UNITED STATES PATENT AND TRADEMARK OFFICE

APPLICATION NO.	FILING DATE	FIRST NAMED INVENTOR	ATTORNEY DOCKET NO.	CONFIRMATION NO.
09/905,099	07/16/2001	Kenji Kawazoe	1272.C0468	3548

Office Action Summary	Application No. 09/905,099	Applicant(s) KAWAZOE ET AL.	
	Examiner Ly T TRAN	Art Unit 2853

DETAILED ACTION

FIG. 1

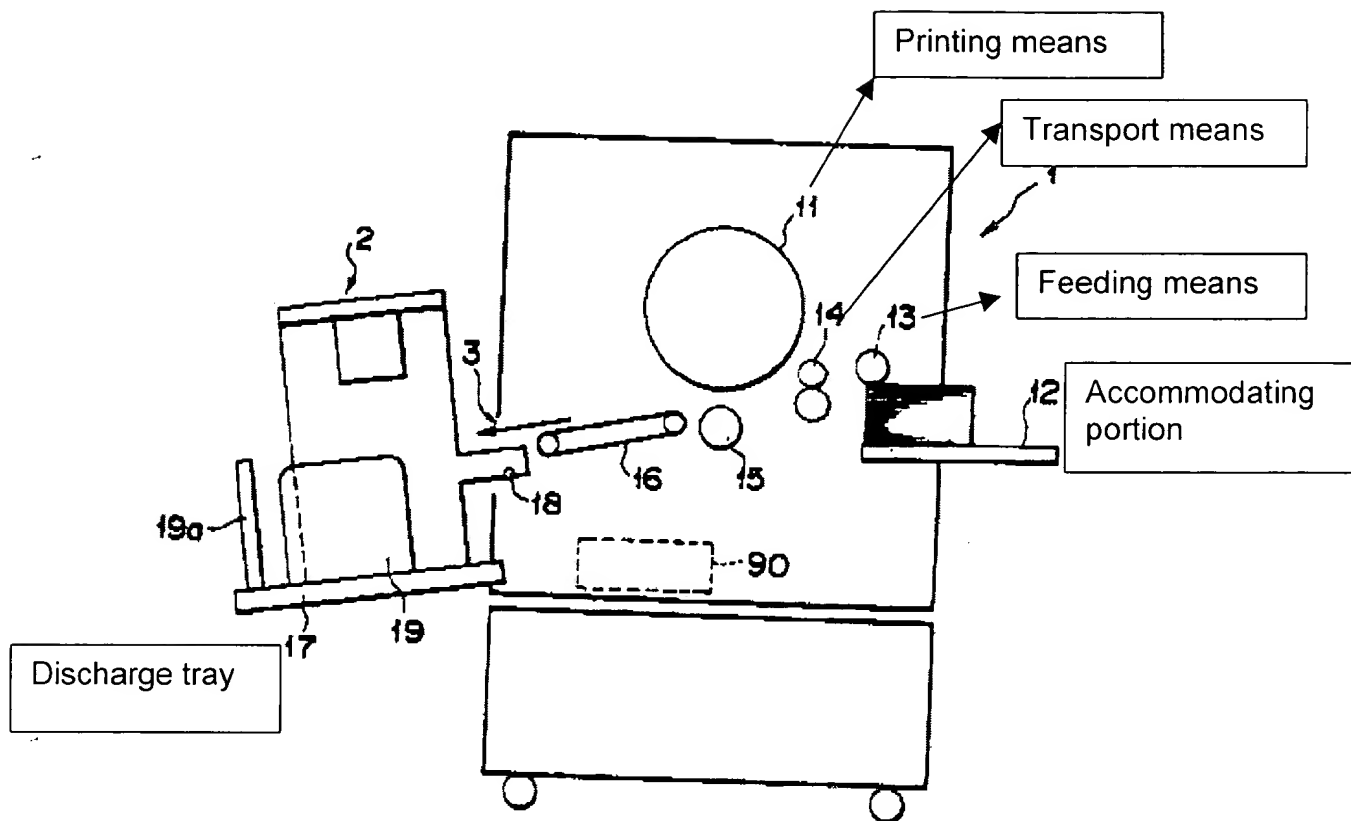
means wherein at least one of the transport means and the discharge means transports the print medium along the transporting passage so that the printing means can print on the print medium and wherein after the print medium accommodated in a predetermined accommodating portion has been fed to the transporting passage (Fig. 1 element 3, 17, 21, Column 3: line 41-43, line 44-48, line 52-54, line 61-62), at least one of the transport means and the discharge means transport the printing medium along the transporting passage so that the printing means can print on the print medium (Fig. 1: element 14, 15) and a distance from a front end of the accommodating portion to the feeding means is set smaller than a width of the discard area in the front end portion of the print medium (Fig. 1: show that the discharge roller 13 is on the top of the end portion of the accommodating portion 12, therefore the distance from a front end portion of the accommodating portion to the feeding means must be smaller than a width of the discard area in the front end portion of the print medium)

It would have been obvious to one having skill in the art to routine experimentation of the accommodating portion has a dimensional setting such that a distance from a most downstream position printed by the printing means to the discharge means is set larger than a width of the print medium, a distance from a most upstream position printed by the printing means to the transport means is set smaller than a width of the discard area provided in the rear end portion of the print medium and a distance from a most downstream position printed by the printing means to the discharge means or a distance from a most upstream position printed by the printing means to the transport means, whichever is a greater distance, is set smaller than a

width of the discard area provided in the front end portion of the print medium and a distance from a most upstream position printed by the printing means to the transport means is set smaller than a width of the discard area provided in the rear end portion of the print medium.

It would have been obvious to one having ordinary skill in the art the time the invention was made with feeding means, a discharge means, wherein after the print medium accommodated in a predetermined accommodating portion has been fed to the transporting passage, at least one of the transport means and the discharge means transport the printing medium along the transporting passage so that the printing means can print on the print medium and a distance from a front end of the accommodating portion to the feeding means is set smaller than a width of the discard area in the front end portion of the print medium as taught by Chida et al. The motivation of doing so is in order to indicate of an abnormal state and improving the printing efficiency of the printing machine.
